CITY OF ALBUQUERQUE

RE: Lot 17 Block 6 SAD 228
Volcano Cliffs Subdivision Unit 19
6309 Vista Del Prado NW
Grading and Drainage Plan
Engineers Stamp Date 3/29/2020 (D10D003F17)
Pad Certification Date 4/26/2020
CO Certification Dated: 12/10/2020

Based upon the information provided in your submittal received 12/14/2020, this plan cannot be approved for Certificate of Occupancy until the following comments are addressed.

GRADING AND DRAINAGE PLAN

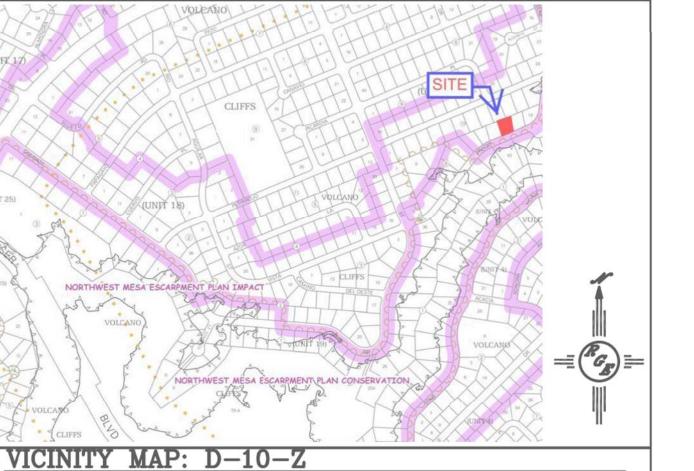
• South side yard and rear yard not following G&D plan. Concrete placed not allowing flows to exit into front yard.

- North side yard missing swale directing flows to front yard.
- Wire trash pen in neighbor's yard, out house in neighbor's yard.
- Pond in SE corner of yard smaller than proposed.
